**Monks Orchard Residents' Association  
Planning**

<b>Reference:</b>	<b>19/04149/FUL</b>
<b>Application Received:</b>	<b>Mon 02 Sep 2019</b>
<b>Application Validated:</b>	<b>Mon 02 Sep 2019</b>
<b>Address:</b>	<b>151 Wickham Road Croydon CR0 8TE</b>
<b>Proposal:</b>	<b>Erection of a two-storey stepped, side and rear extension with alterations to the roof and additional rear dormer, retention of the existing commercial unit and construction of four additional self-contained apartments.</b>
<b>Status:</b>	<b>Awaiting decision</b>
<b>Case Officer:</b>	<b>James Udall</b>
<b>Consultation Close:</b>	<b>Fri 27 Sep 2019</b>
<b>Deadline determination:</b>	<b>Mon 28 Oct 2019</b>

**Policies Map for 151 Wickham Road**

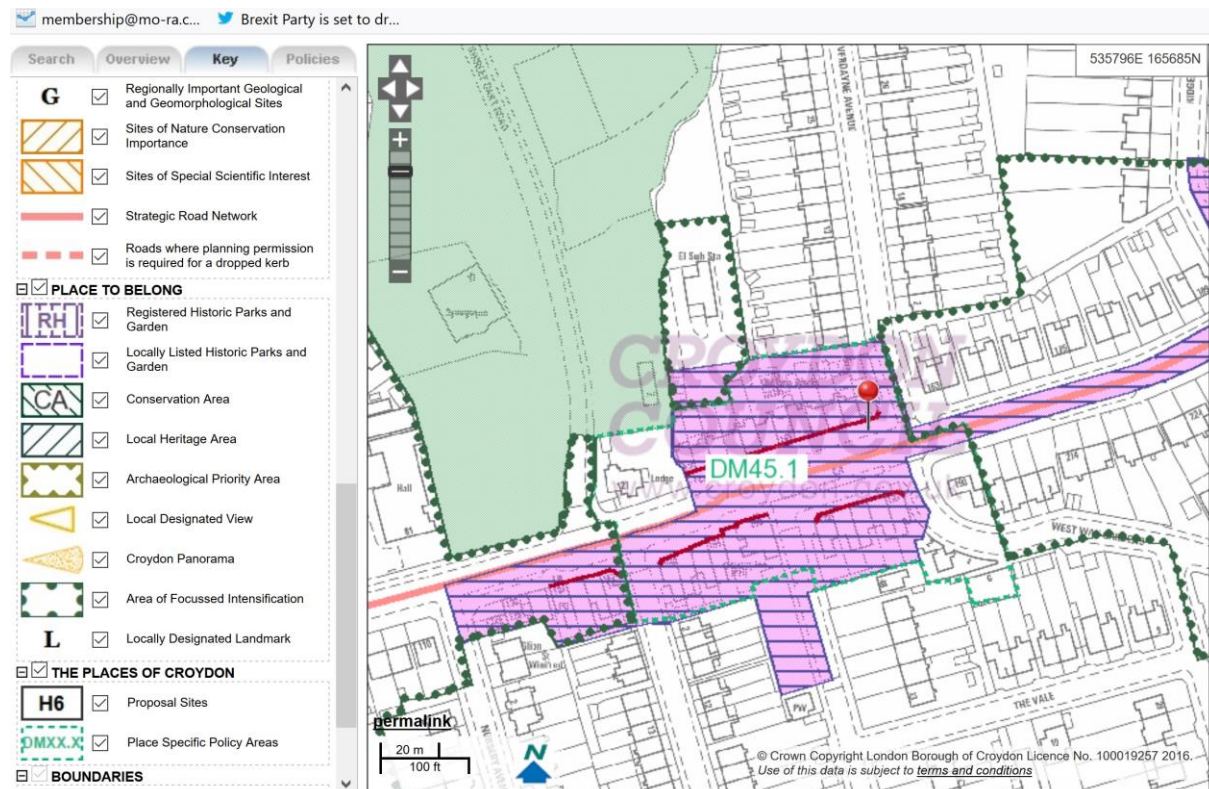
The Policies Map shows that this proposed development is within the **(Urban) Shirley Primary Shopping Area DM45.1** but is NOT within an area designated for "Focussed Intensification".

**Illustration of the excessive PTAL Requirement above the Local available PTAL due to Increased Residential Densities of Planning Applications in the MORA Post Code Area showing the ongoing PTAL linear trend requirement.**

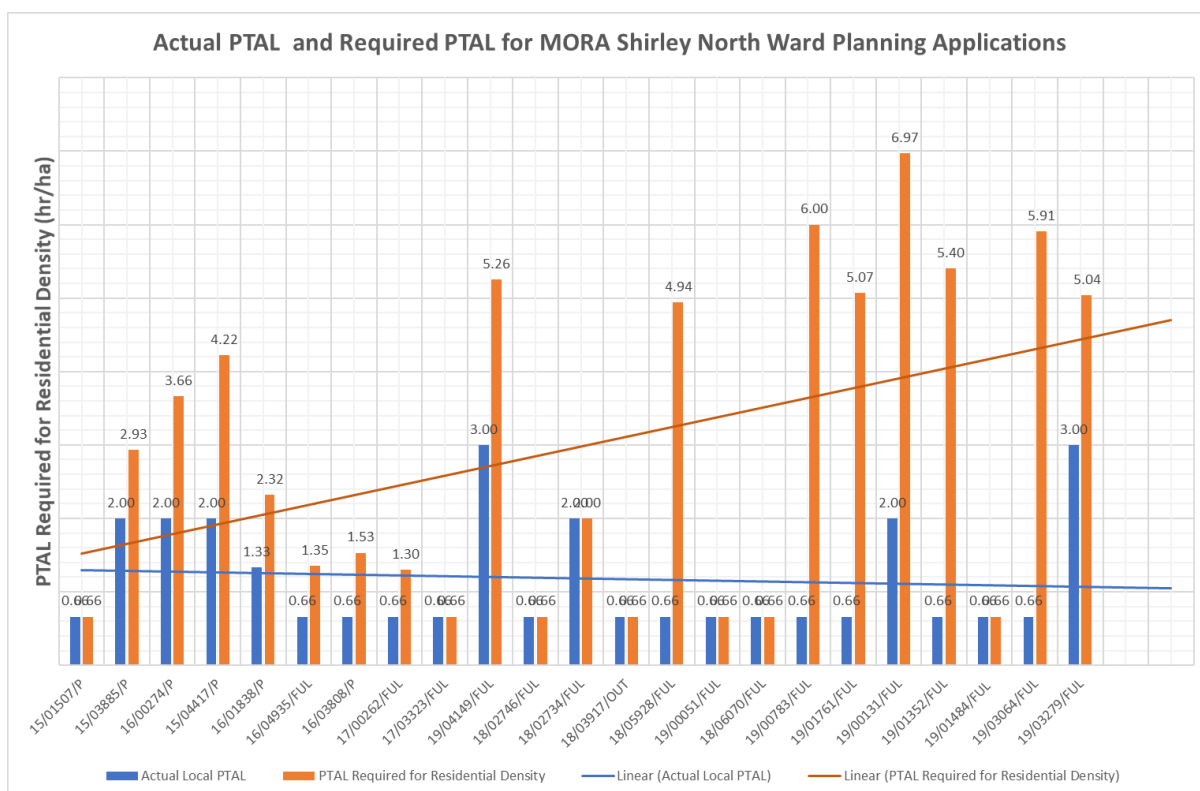
The following Histogram illustrates recent cumulative development proposals, showing the actual PTALs and the Recommended PTALs based upon the current adopted London Plan Policy 3.4 - Optimising Housing Potential and shows the trend lines for recent applications in the MORA Post Code Area.

The Histogram above Illustrates the cumulative excessive PTAL Requirement above the Local available PTAL due to Increased Residential Densities of Applications in the MORA Post Code Area and also shoes the ongoing PTAL linear trend requirement.

**This is clear evidence that there is no management of cumulative developments within the locality and there has been no easement resultant on Community Infrastructure Levy (CIL) from local developments in the Shirley Wards.**

### Proposed Elevation from Verdayne Avenue showing Roof Forms

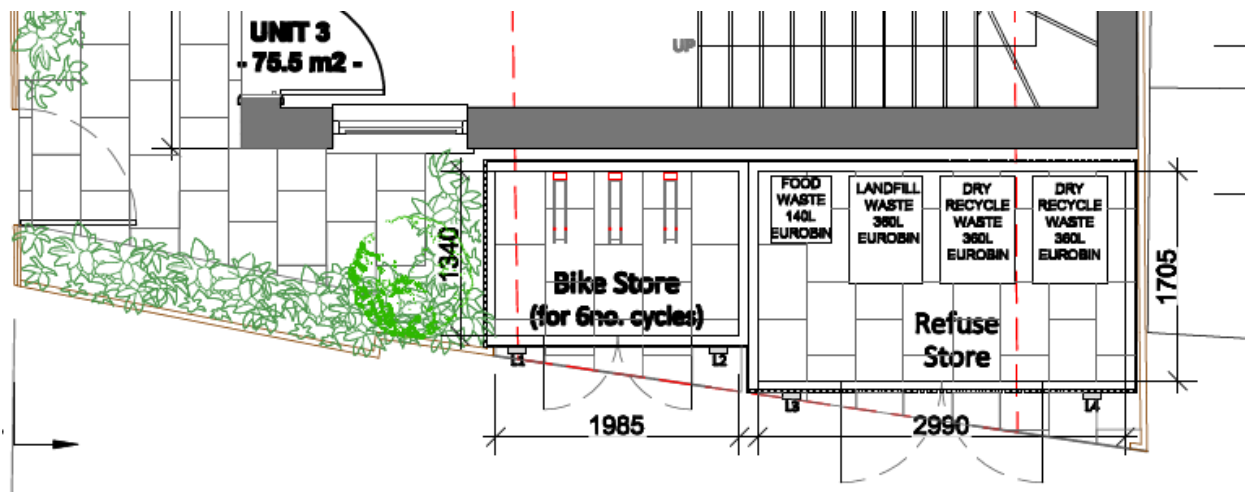
The **Flat roof-forms** for **Unit 2** and **Unit 3** do not positively contribute to the local character **roof forms** as all local roof forms are of pitched tiled roofs. This detracts from the historic architecture of the local Centre and should therefore be avoided and the roof form of local character be implemented. Therefore, this proposal is **non-compliant** to **DM10.7 para d)** and should be refused. (See Elevations below)
